QUICK REACTION REPORT ON THE BAGHDAD POLICE COLLEGE BAGHDAD, IRAQ

SIGIR PA-06-078.1 SIGIR PA-06-079.1 SEPTEMBER 27, 2006

SUBJECT: Quick Reaction Report on Assessment of the Baghdad Police College, Baghdad, Iraq (Report Numbers SIGIR-PA-06-078.1 and PA-06-079.1)

Site Photo 6. Water damage to second floor bathroom ceiling

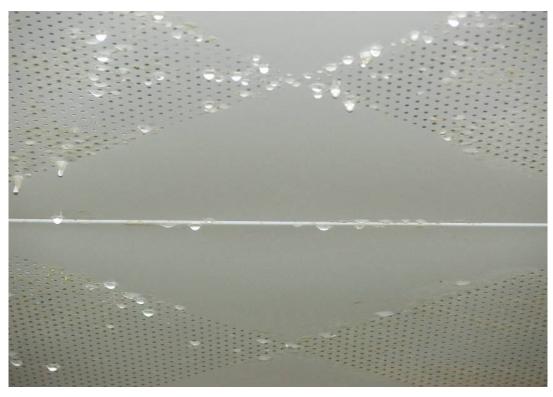
During our site visit, we immediately identified water damage and staining on the ceiling and walls of the ground floor (Site Photos 4 and 5). We toured the second floor bathroom and saw evidence of similar water damage and staining on the ceiling (Site Photo 6).

Site Photo 17. Close-up view of far left bathroom light not operating because it is full of diluted urine and fecal matter

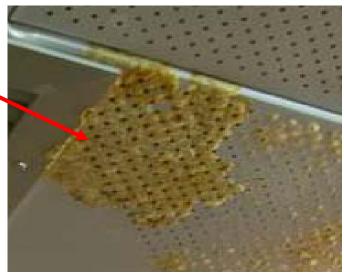
As a result of the inferior plumbing techniques, methods, and bonding materials used by the contractor to join the wastewater pipes, water and other waste materials from showers, wash basins, and toilets are continually draining through the reinforced concrete floors, from the top floor to the second floor to the ground floor, permeating and filling light fixtures, showers, and toilet areas, with liquids, including diluted urine and fecal matter. For example, we witnessed a light fixture so full of diluted urine and feces that it would not operate (Site Photos 16 and 17). As we continued

our assessment throughout the second floor bathroom, we identified evidence of large quantities of diluted urine dripping from the top floor down through the ceiling. The urine was so pervasive that it had permanently stained the ceiling tiles (Site Photos 18 and 19). During our visit, a substance dripped from the ceiling onto an assessment team member's shirt (see Site Photos 20 and 21).

Site Photo 22. New pipe installed to correct the leak

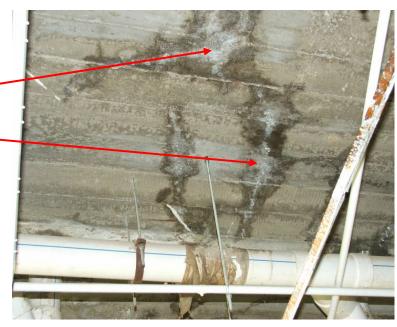
As soon as the buildings started to leak from the top floor to the ground floor, the Director of the Baghdad Police College contacted the contractor. Parsons directed the subcontractor who performed the original work to correct the problem. The subcontractor is currently changing out the pipes that contributed to the leaks. For example, Site Photo 22 shows new pipe installed to correct the leakage problem identified in Site Photos 12 and 13, respectively. The subcontractor also plans to use the pipes with molded plastic fittings, such as the one identified in Site Photo 15, which should eliminate water and waste materials from flowing directly onto the concrete floors in the future.

Underside of 3rd story Concrete floor slab cracks soaked through with extensive urine, fecal matter and efflorescence.

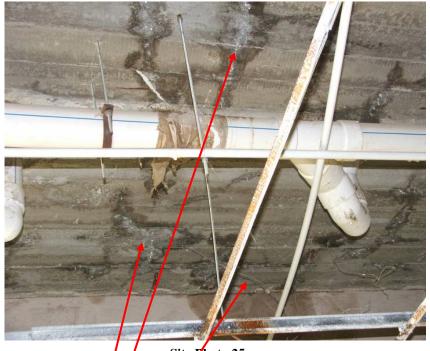
Even though the subcontractor is taking steps to correct the problem, the Baghdad Police College staff and students still have to deal with the damage caused by the poor subcontractor workmanship. In addition to water and waste materials soaking and filling light fixtures, showers, and toilets on the ground and second floors, the amount of material was so pervasive that it has soaked through the reinforced concrete floors causing deterioration of the reinforcing steel, and leaching of the chemical salts that are necessary for the proper strengthening of the concrete. The visible salt deposits, known as efflorescence, are readily apparent on the underside of the slabs (Site Photos 23-26). The subcontractor is making the corrections needed to fix the original problem; however, the subcontractor did not make any assessment of the damage already done including the structural integrity of the reinforced concrete slabs for each floor of the building. The Director of the Baghdad Police College is also concerned that the rust, mold, and presence of urine and fecal matter caught within the concrete floors presents a serious threat to the health of all Baghdad Police College students and staff. Further, if an environmental and/or health hazard is present at the Baghdad Police College, the number of basic recruits graduating through the facility will be impacted.
